#### Final author comments on behalf of all co-authors

## Referee #1: David Pyne

# Referee #2 (Anonymous)

# Consequences and mitigation of saltwater intrusion induced by short-circuiting during aquifer storage and recovery (ASR) in a coastal subsurface

Figure 2: Locations of ASR (AW), ATES, and monitoring wells (MW).

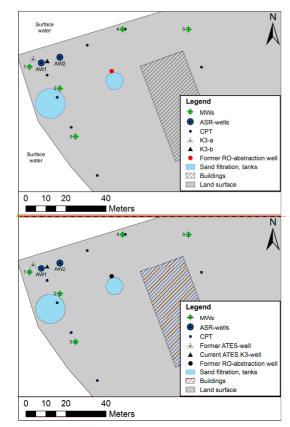
14 1 The monitoring wells shown in Figure 2 have not been mentioned in the text.

Author's response: This information is now reported in text and in the table as requested by the reviewer

Table 41: Hydrogeological properties of the geological layers in the Westland SEAWAT model

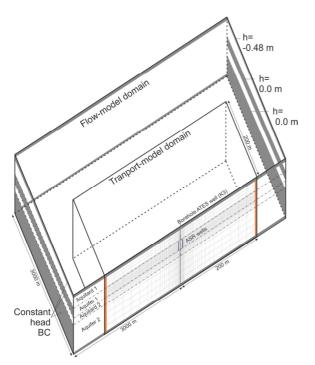
6 Table 1 Suggest removing VANI heading. Suggest adding more detail to show properties of each layer.

**Author's response:** The authors feel that the table (including VANI) provides the relevant characteristics of the model layers. VANI is replaced by reporting the  $K_v$  in this column for the sake of clarity.

Figure 5: Pumping of the ASR system during cycle 1 (2012/2013), EC observations at MW1 (5 m from AW1), and the EC in the recovered water at AW1 and AW2. MW= monitoring well, AW= ASR well.

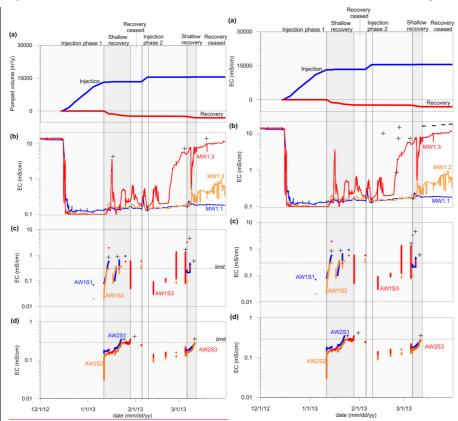
9 Figure 5 Discussion on mixing is based on Cl, but you are showing EC in Figure. Suggest plotting EC, Cl and SO4.

9 Figure 5 Suspect part a y-axis should be volume not EC.

**Author's response:** We thank the reviewer for this suggestion. However, the reason to plot the EC here is the extremely high frequency of the analyses, which gives far more information that the regularly measured Cl.

**Author's response:** Indeed, the authors amended the title on this axis (correct = pumped volume  $(m^3/yr)$
